December 2015 Technical Service

### SUBJECT Door Brake Makes Squeaking Noise

**MODEL** E89 (Z4 sDrive Roadster)

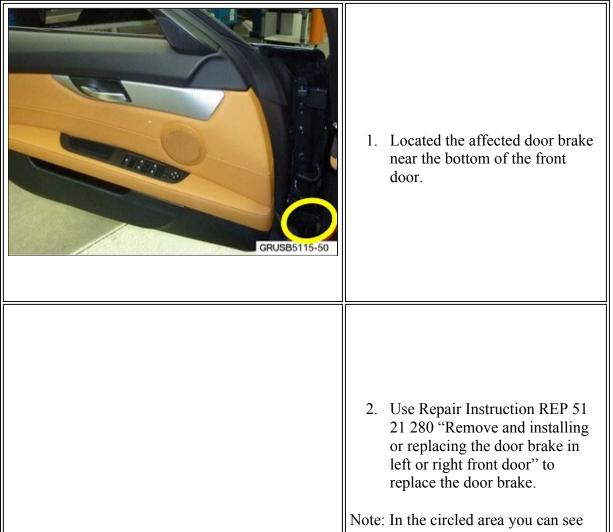
The customer may complain of a squeaking noise when opening or closing either front door.

Debris inclusions imbed into the door brake slide mechanism.

Replace the affected door brake with the revised part listed below.

Part Number	Description	Quantity
51 21 7 128 267	Door brake (revised)	1 or 2 as needed
